June 26, 2026

**Subject: VLO-25-03 West Village (315 N Lapeer Road), Final Site Plan Review
Planning Commission Reconsideration**

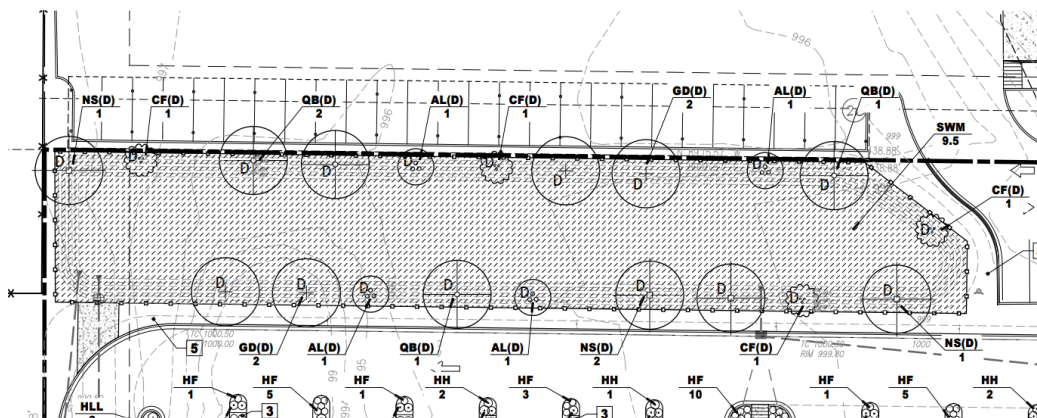
Landscaping and Plant Material. The applicant has provided a landscaping plan on sheets LP.01 and LP.02.

The proposed detention pond landscaping is shown inside of the fence, on a 1:1 slope (1' vertical for every 1' horizontal). The Design and Construction Standards found in Chapter 151 of the Village's Code of Ordinances requires a retaining wall or armored slope for all slopes over 1:3. Since the proposed slope will be required to conform to the standards of Chapter 151, the location of the proposed trees will need to be revised.

Due to the limited space available for the placement of trees, the Planning Commission should consider requesting changes to the site plan to meet the landscaping requirements, or consider relief to the applicant by waiving some of the requirements, per Section 15.02.F.1.d:
